| APPLICATION NO. | FILING DATE | FIRST NAMED INVENTOR | ATTORNEY DOCKET NO. | CONFIRMATION NO. |
|---|-------------|----------------------|-----------------------------|------------------|
| 10/614,354 | 07/07/2003 | Thomas J. Sonderman | 2000.100800 | 7900 |

Office Action Summary

DETAILED ACTION***Claim Rejections - 35 USC § 102***

**FIG. 1**

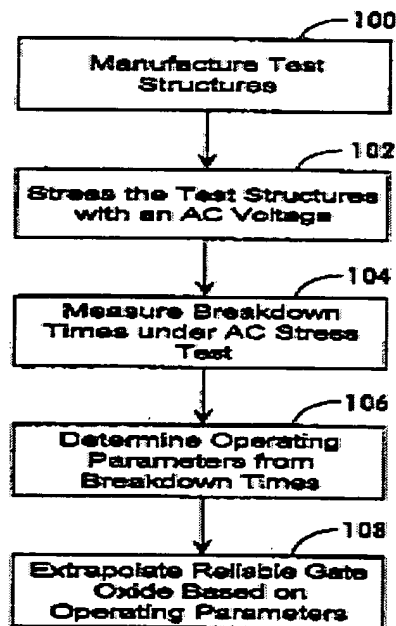
In re claims 1 and 9, Fang discloses a method, comprising: performing at least one electrical test **102** on at least one flash memory device (col. 1, lines 35-48) to determine a duration of a programming cycle **104** performed on the flash memory device;

determining at least one parameter **106** of at least one process operation to be performed to form at least one gate insulation layer **108** on a subsequently formed flash memory device based upon the determined duration of the programming cycle (col. 3, line 66 to col. 4, line 35 and FIG. 1); and

performing the at least one process operation comprised of the determined at least one parameter to form at least one gate insulation layer **108** on the subsequently formed flash memory device (col. 4, line 36 to col. 5, line 21 and FIG. 1).

FIG. 1

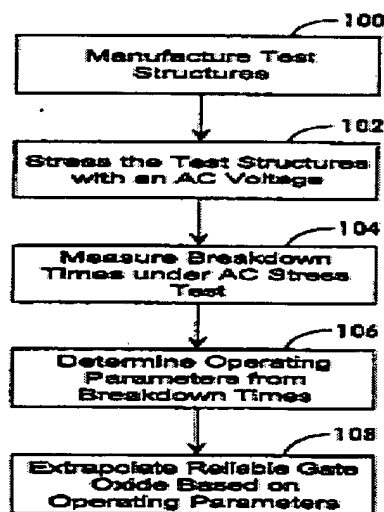
In re claims 21 and 22, **Fang** discloses a method, comprising: performing at least one electrical test **102** on at least one memory device (col. 1, lines 35-48) to determine a duration of a programming cycle **104** performed on the memory devices;

determining at least one parameter **106** of at least one process operation to be performed to form at least one gate insulation layer **108** on a subsequently formed

memory device based upon the determined duration of the programming cycle (col. 3, line 66 to col. 4, line 35 and FIG. 1); and

performing the at least one process operation comprised of the determined at least one parameter to form **108** at least one gate insulation layer on the subsequently formed memory device (col. 4, line 35 to col. 5, line 21).
